**PLS RESPONSE TO MDEQ JUNE 19, 2008 MEMO
REGARDING REVIEW OF EVERGREEN SYSTEM
CAPTURE EFFECTIVENESS**

August 7, 2008

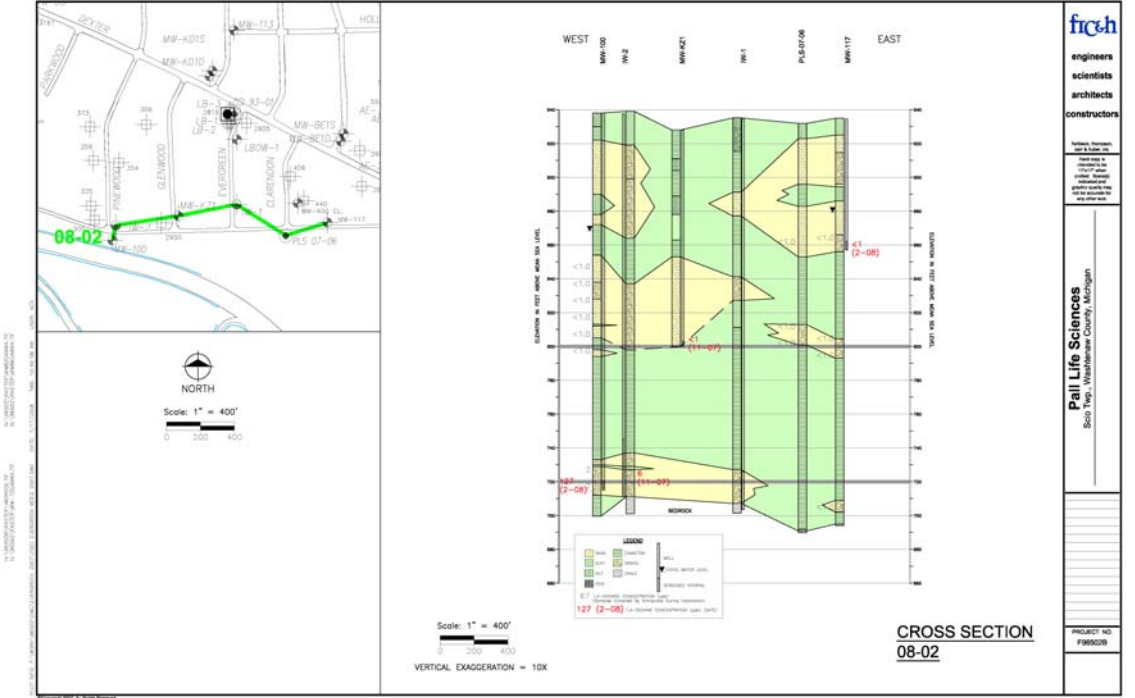
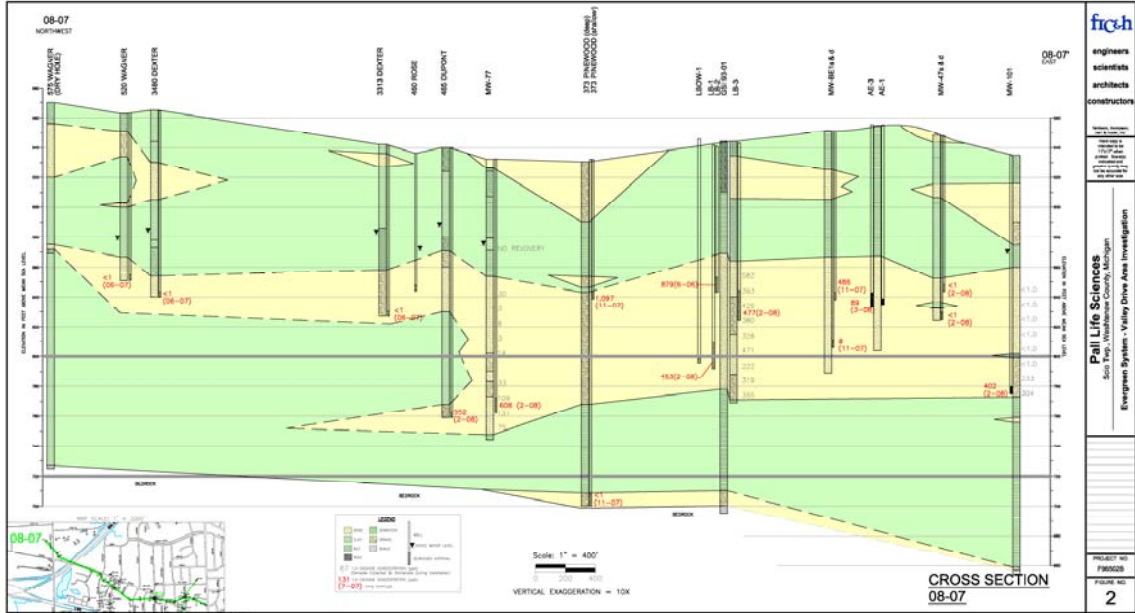
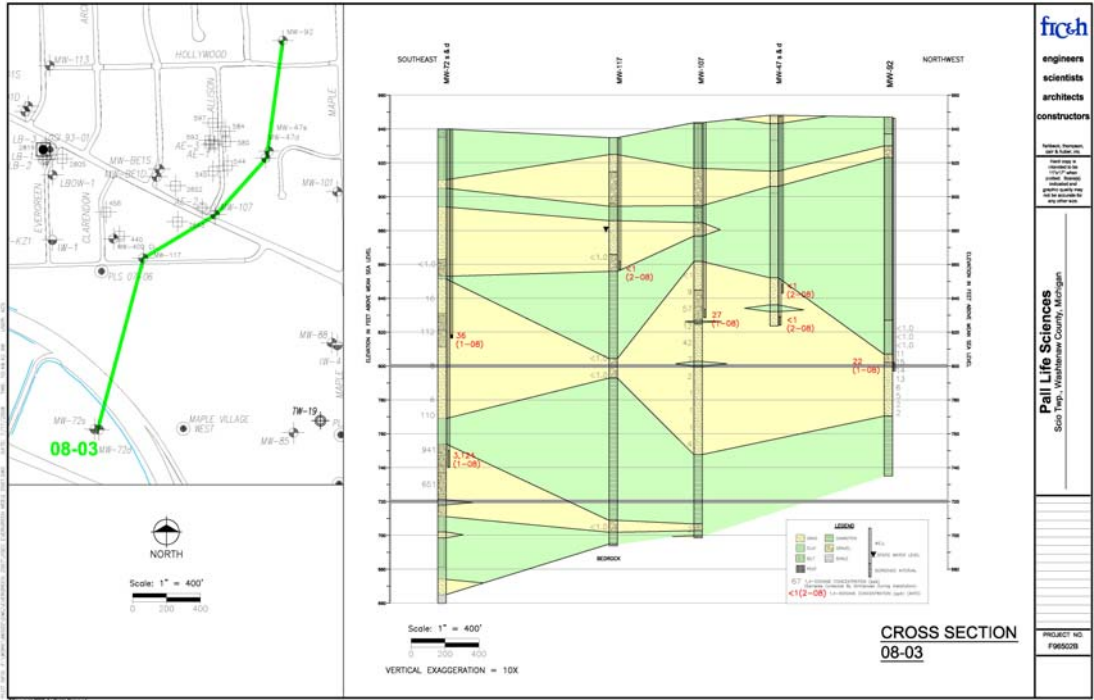
The MDEQ’s assertion that “there has been no vertical sampling of the aquifer to determine the horizontal and vertical extent of 1,4-dioxane concentrations that require containment at Evergreen or Allison Streets” is simply wrong.

As MDEQ is well aware, PLS has done an extraordinary amount of vertical sampling as part of its site investigations. With very few exceptions, borings are routinely drilled to

the bedrock surface with vertical aquifer samples collected in all water bearing units. The ability (technology) to do such sampling accurately and efficiently to the depths sufficient to encounter bedrock has not always been available. At some historic locations, and with MDEQs full approval, PLS utilized the techniques then available, such as installing nested wells, to measure and monitor the vertical distribution of 1,4-dioxane in the aquifers. The locations and depths of the nested wells were selected only after a critical review of aquifer characteristics such as grain size distribution, aquifer thicknesses and 1,4-dioxane distribution information. PLS routinely discussed these screen placements with MDEQ before the wells were installed.

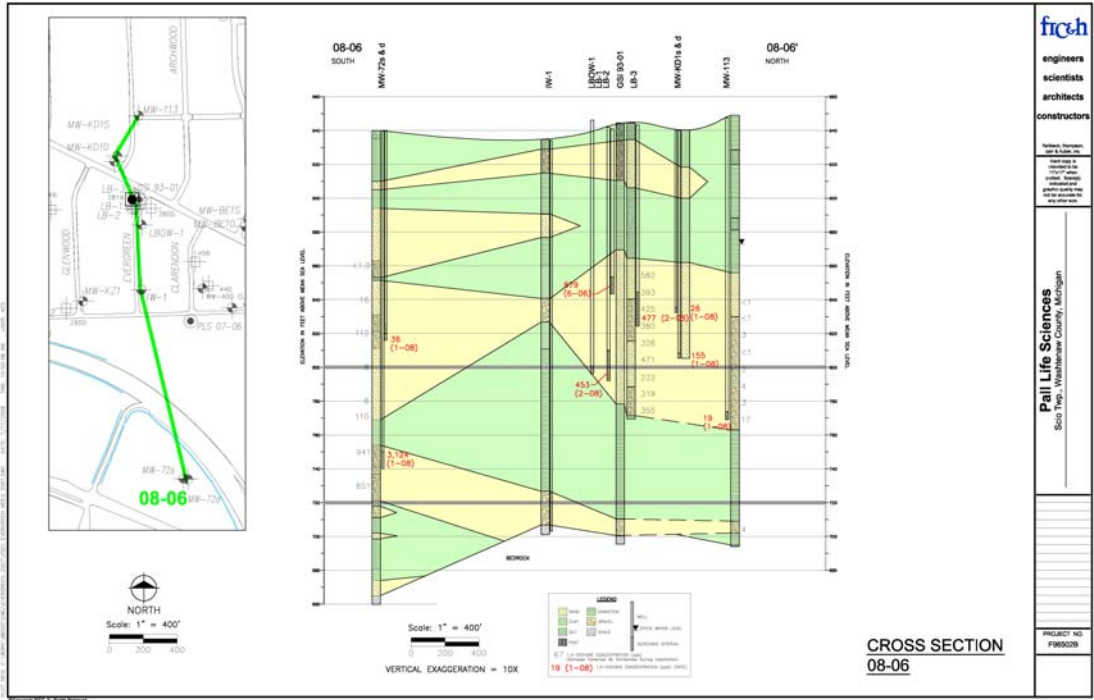
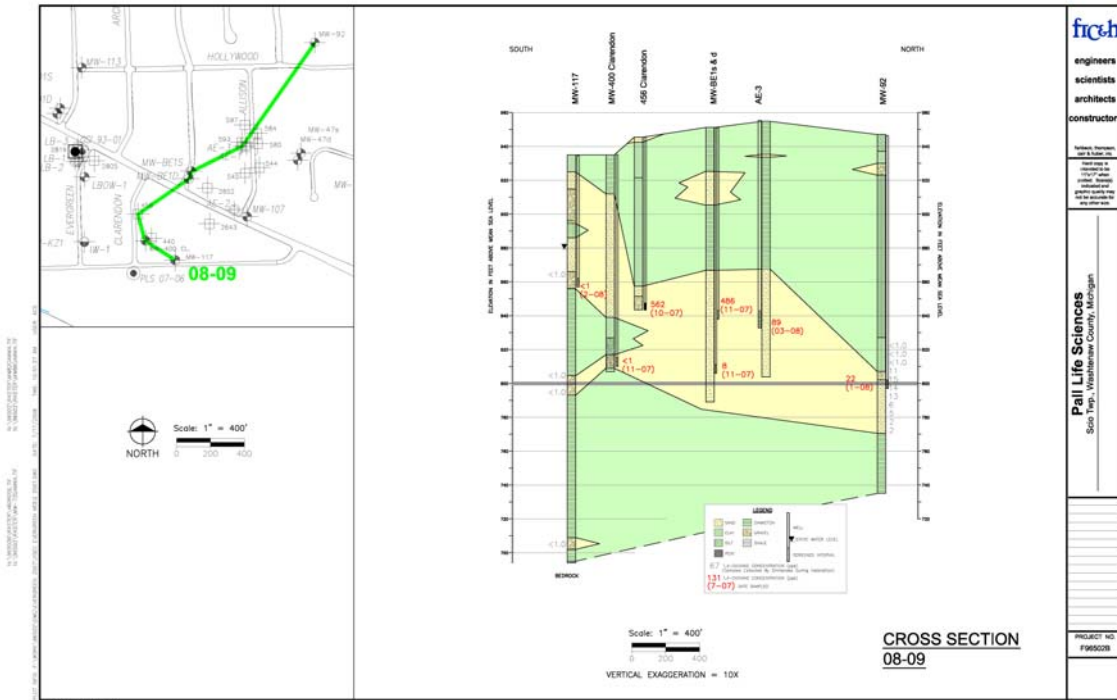
An assessment of hydraulic gradients begins with an examination of hydraulic-head data or a potentiometric surface map. Figure 7 from the Valley Drive report shows the interpreted potentiometric surface of the “D2” aquifer. There are a couple of issues that we have with this map. The first is that head data from wells that are screened in zones that appear to be hydraulically-isolated from the aquifer within which the 1,4-Dioxane plume is found were used to prepare this potentiometric surface map. These data and the resulting potentiometric surface contours do not “make sense” given the contaminant migration direction of the 1,4-Dioxane plume that has been presented by FTC&H. The wells in question are found northwest of M-14 (along Wagner Road or Rose Drive) and along Valley Drive. It’s our opinion that these wells reflect either “perched” or local flow conditions, or zones that are not well-connected to the “D2” aquifer. Focusing on the Evergreen wells, we do not believe that the potentiometric surface “high” centered on well MW-KZ1 is representative of heads or contaminant migration directions within the “D2” aquifer in this area. The relatively-high head measured in this well shows that there is significant resistance to groundwater movement between the screened interval in this well and the contaminated aquifer. This well appears to be screened in a zone that is not well-connected to the aquifer in which the contaminant plume is found. MW-KZ1 and MW-117 (discussed below), should not be used in preparing a potentiometric surface map for this aquifer. Taking these two wells out of the dataset used to map the potentiometric surface results in a surface that looks similar to the surface shown for the deeper “E” aquifer (see Figure 8 of the DuPont report, Unit E2 and Deeper DuPont Area Wells Potentiometric Surface Contour Map – February 25, 2008).

PLS Response – The MDEQ suggests that wells MW-KZ1 and MW-117 are somehow disconnected or “perched” from Unit D2. The MDEQ has presented no data to support this opinion. PLS’ interpretations of how these wells relate to various hydrofacies have been presented in various cross sections submitted to the MDEQ. These and other sections are provided again below. The MDEQ has never provided alternative interpretations or cross sections to those made by PLS that would explain how these two wells are isolated from the Unit D2. Therefore it is difficult for PLS to evaluate the basis for the MDEQ’s new interpretation.

MW-KZ1 is completed at an elevation of 800 feet, the same depth as the LB-1 extraction well. Reasonable interpretations suggest this well is completed in the same aquifer as the LB-1 well. As such, PLS sees no justification for excluding water level data from this well.

The recently installed MW-117 is completed at a higher elevation (approximately 860 ft amsl). A review of cross section 08-09 indicates this well is completed slightly higher than the well at 546 Clarendon, which is obviously in the D2 aquifer based on the presence of 1,4-dioxane. When field decisions were being made regarding the completion of this well, it was decided to place it at this elevation to monitor the same zone as the contaminated well at 546 Clarendon. In our cross section interpretation, PLS has correlated this well to be hydraulically connected to the 546 Clarendon completion aquifer. Alternative interpretations to those made by PLS could result in MW-117 being completed in a hydrofacies above the one associated with Unit D2.

As interpreted on the cross sections 08-03 and 08-06, the hydrofacies associated with the Unit D2 plume to the north and the Unit E1 plume to the south are restricted in the area between MW-117 and IW-1. MDEQ ignores the presence of this important hydraulic feature, even though it appears to have an important role in separating the two plumes (as evidenced by the clear absence of 1,4-dioxane in this area) and as a possible explanation for the higher heads observed in this area.

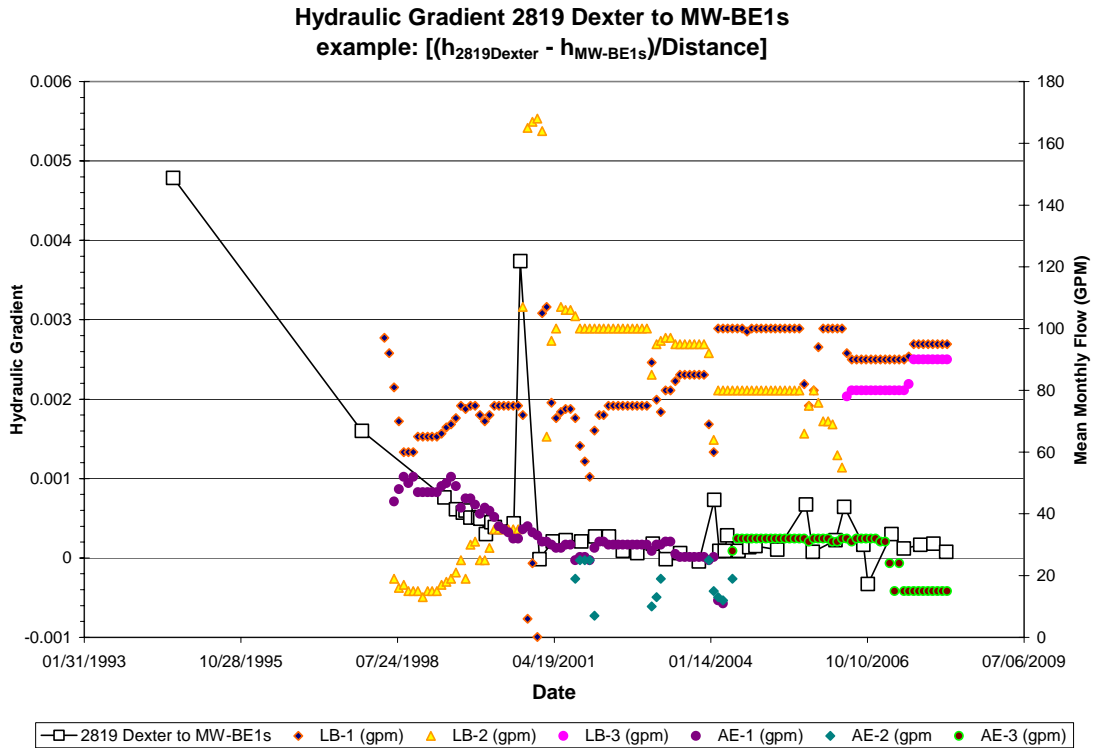
The second issue is related to the drawing of a cone of depression (828-foot contour) around well LBOW-1, a non-pumping well. There does appear to be a “flattening” of hydraulic gradients in the vicinity of the LB wells, even after removing wells MW-KZ1 and MW-117. However, because the distribution of wells for monitoring hydraulic containment is not optimum or sufficient, it is difficult to determine whether a cone of depression is centered over the LB wells (the pumping wells), and whether there are hydraulic gradients toward wells LB-1 and LB-3, a necessary requirement to demonstrate hydraulic containment. The result is that the available data show no well-defined hydraulic gradients toward these extraction wells or hydraulic containment.

PLS and the MDEQ agree that the data indicate that there is a very flat hydraulic gradient in the area east of the LB wells, making it difficult to interpret the extent of capture in this direction solely from water level data. As discussed further below, this flattening of the hydraulic gradient is a result of years of continuous extraction and is an obvious indicator of the hydraulic influence that operation of the extraction wells has had on the aquifer (water levels in the Evergreen area have dropped up to 7 feet since operation of the Evergreen System). The flat hydraulic gradient is also created, in part, by the dual pumping of the LB and AE well sites, which sets up hydraulic competition

between the two purge locations. The absence of a well defined capture zone between the two extraction points is a result of the hydraulic characteristics of the aquifer, not the distribution or lack of measurement points. As explained below, it is unlikely that additional monitoring wells will provide greater definition of the capture zone east of the LB wells.

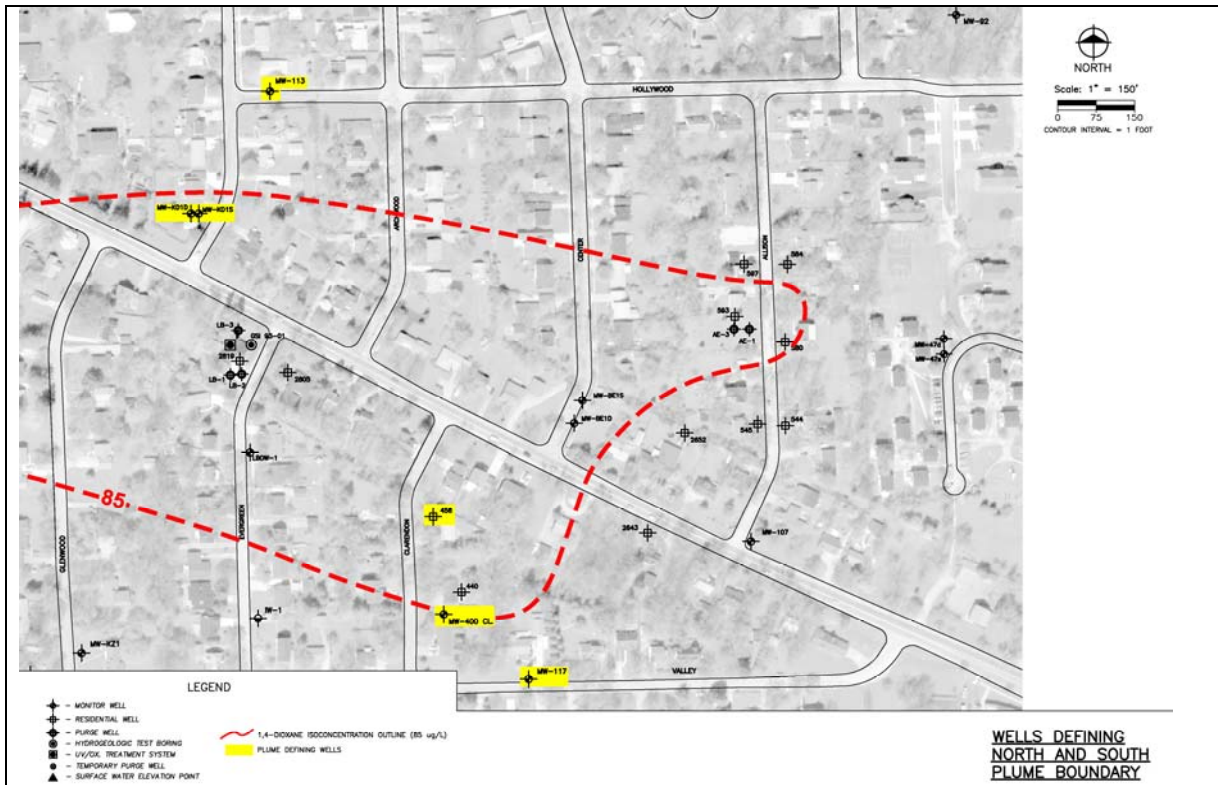
Figure 6 shows the 1,4-Dioxane concentrations at the wells at 440 Clarendon and 456 Clarendon, along with pumping rate for the LB wells. Groundwater samples have been collected at 456 Clarendon since 1997 through the present, while sampling from the well at 440 Clarendon was stopped at the end of 2004. Data on this graph shows that concentrations of 1,4-Dioxane at 440 Clarendon and 456 Clarendon have continued to increase since 1997.

Pumping from LB-1 and/or LB-2 may have had an impact on stabilizing 1,4-Dioxane concentrations at 456 Clarendon (see graph between 2001 and 2005). We believe that the increase in concentrations from 2005 to the present at 456 Clarendon may be attributed to a reduction in pumping at LB-2 and shifting the pumping to LB-3, or simply a movement of contaminants from the west and south of the LB-series wells.

PLS Response – *(See the above comment regarding the appropriate compliance point for determining plume containment.) As reflected in the Stipulation regarding the AE-3 dispute resolution petition, the MDEQ and PLS recognized that the 1,4-dioxane detected at this well either originates within the Evergreen Subdivision area and is migrating south of the LB capture zone or is being drawn up from the Unit E1. The goal of the investigation was to determine which was occurring. Both explanations are plausible based on the currently available data. Regardless of the precise pathway of 1,4-dioxane to the Clarendon area, available data support that this area is within the capture of AE-3. This includes data from MW-107, which demonstrates elevated 1,4-dioxane concentrations in the Clarendon area are not moving east toward MW-101, as later suggested by the MDEQ.*

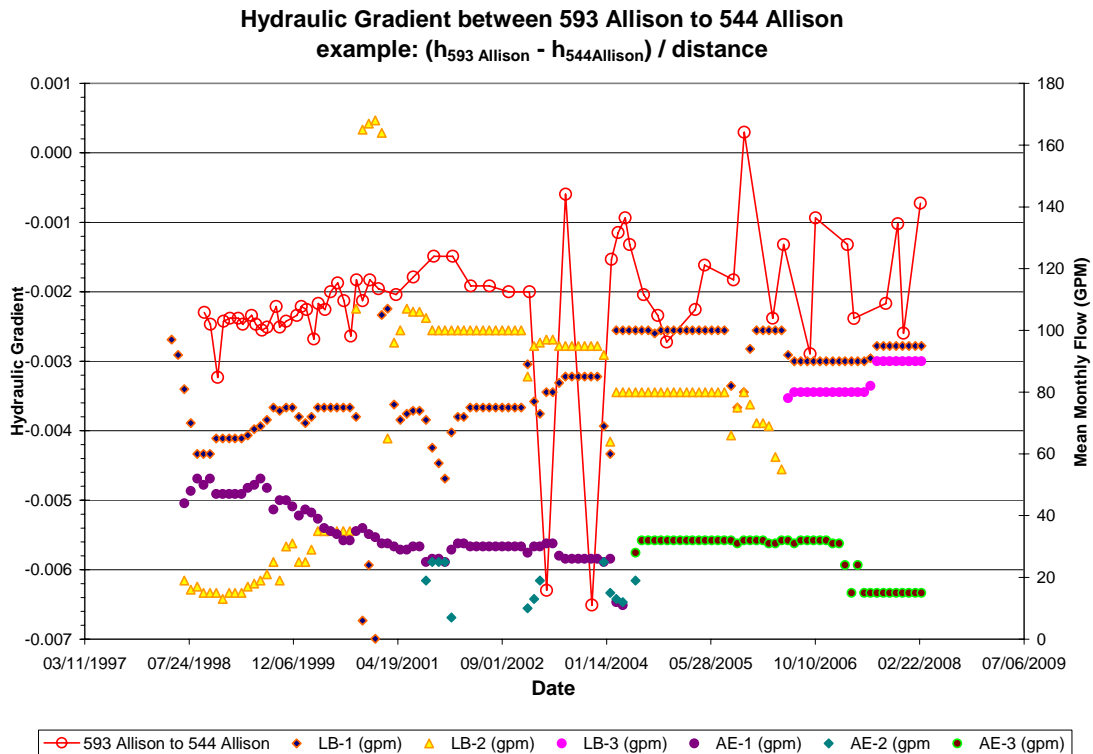
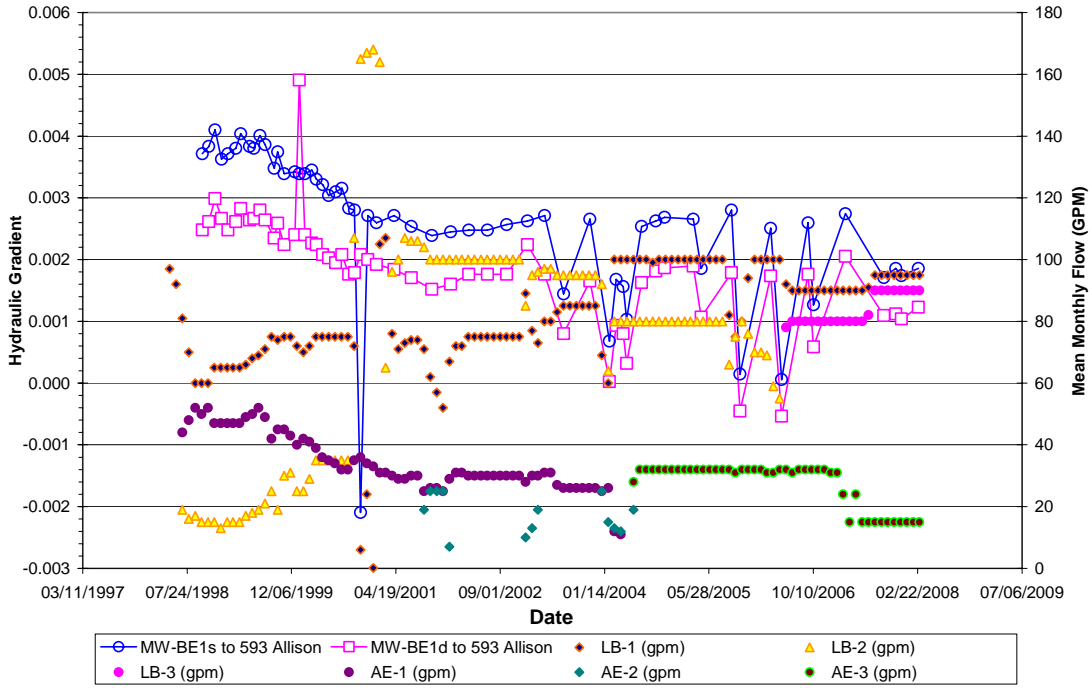
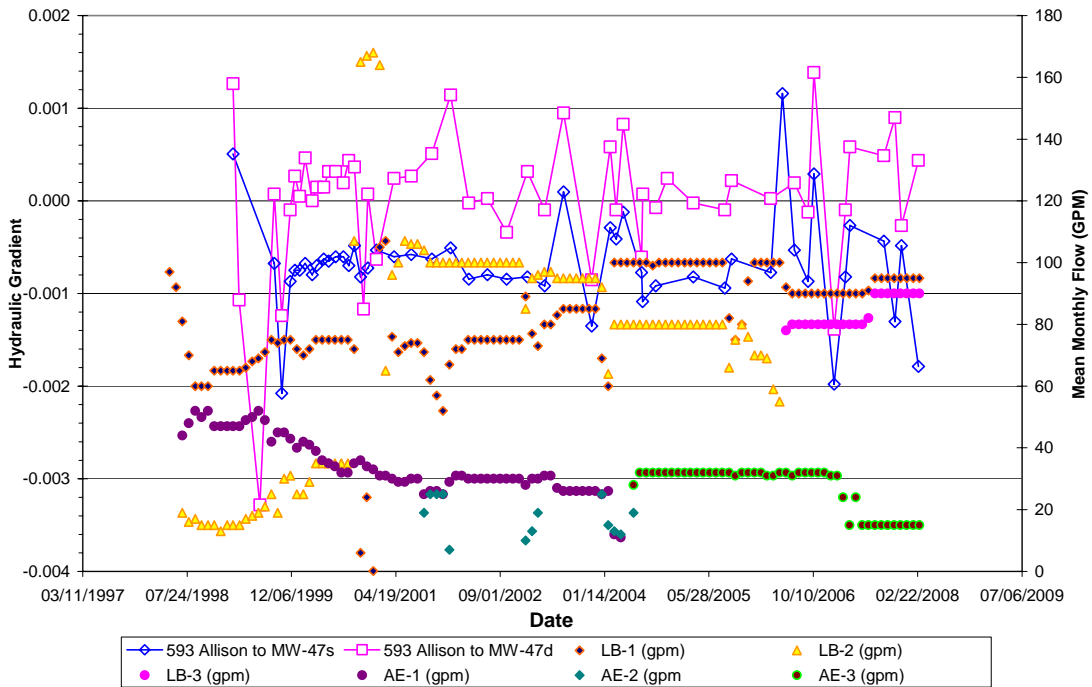
Finally, there are too few monitoring wells near Allison Street to assess hydraulic gradients or hydraulic containment in the vicinity of AE-3. The hydraulic-head data that are available do not show hydraulic containment at this well.

PLS Response – *PLS agrees that the flat hydraulic gradients in the area of Allison Street make it difficult to demonstrate hydraulic containment solely through water level data. That is why PLS also relies on water quality data to confirm the capture zone predictions made through modeling. But PLS disagrees with the MDEQ's assertion that the hydraulic-head data that are available do not show hydraulic containment at this well. As mentioned earlier, use of pumping well data for head measurements is difficult due to hydraulic inefficiencies. As such, PLS does not routinely provide such measurements. The closest well to the AE pumping wells is 593 Allison, which is approximately 30-40 feet from AE-3. Obviously, under pumping conditions, the head in the purge wells would be less than at 593 Allison. This is also supported by water level data from the AE-3 when it was collected by PLS.*

Water level data indicate there is a hydraulic gradient toward AE-3 from the MW-BE1 well nest. There has also been a consistent gradient toward AE-3 from 544 Allison. There has also consistently been a hydraulic gradient toward the AE-3 from MW-47s under pumping conditions. The direction of the gradient between 593 Allison and MW-47d has been mixed, but has mostly been toward 593 Allison. The direction of these hydraulic gradients are consistent with capture zone analyses submitted by PLS, including the recent analysis calculated using the capture zone equation.

The following graphs are provided to support the aforementioned statements and show how these gradients have changed through time in response to pumping.
